# Equipment Technical Bulletin

## Summit TUV Compliance Improvement

*Inside of Summit, TUV Compliant*

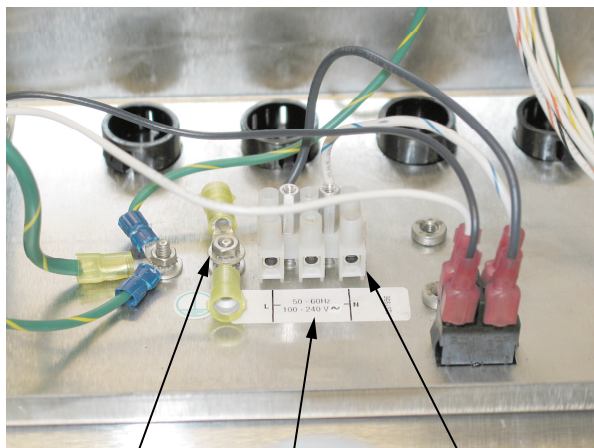
- Grounding changed to ring terminals
- Terminal block was made taller
- Terminal block sticker changed
- Eliminated extraneous labels from inside of pump box
- More translated text added to manual
- TR6000 PCB had minor alterations
- Rating labels for pump box and TR6000 now have TUV's logo; TUV approval is not required on the programmer because it is low voltage.

Ring Terminal  
Terminal Block Sticker  
Moved to Front of Terminal Block  
Taller Terminal Block
